Re: Comments on 200/400G-
ER4/8 Link Budgets (#38,#39);
And is a New PHY required?

Frank Chang
Source Photonics
IEEE P802.3cn Task Force

IEEE P802.3cn Task Force, May 2019 Interim, Salt Lake City, UT, USA

Comments #38, #39 on D2.0 for 200G/400G ER4/8

Table 122–13—200GBASE-FR4, 200GBASE-LR4, 200GBASE-ER4, 400GBASE-FR8, and 400GBASE-LR8, and 400GBASE-ER8 illustrative link power budgets

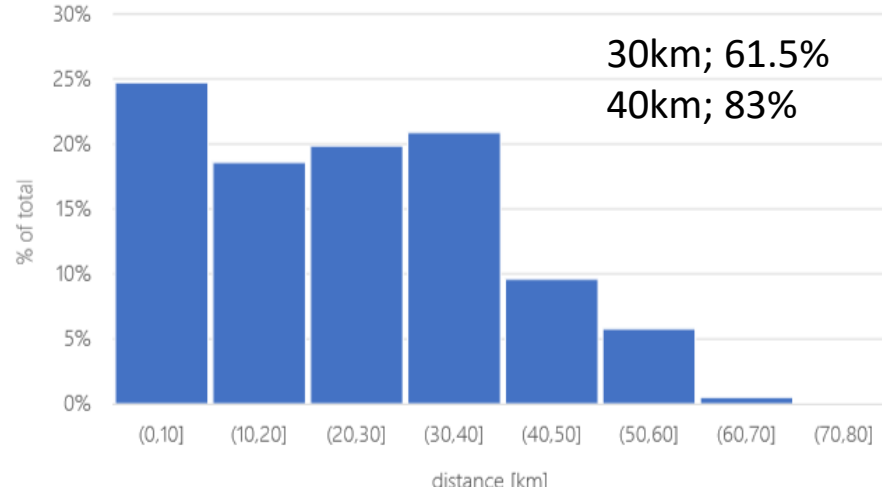
- Current 400G illustrative budgets in Table 122-13 for 30 and 40km follows exactly same 100G format, so may expect similar difficulty in fields.

Question: if we like the standard to be written in more meaningful and compelling manner, how should we handle this situation?

1. *To relax ER4 Tx launching power and RX Sens., for example by 3dB with 30km, can enable low cost modules because of good yield.*
2. *While 40km module will share the same BOM as 30km and can tolerate higher cost with worse yield.*
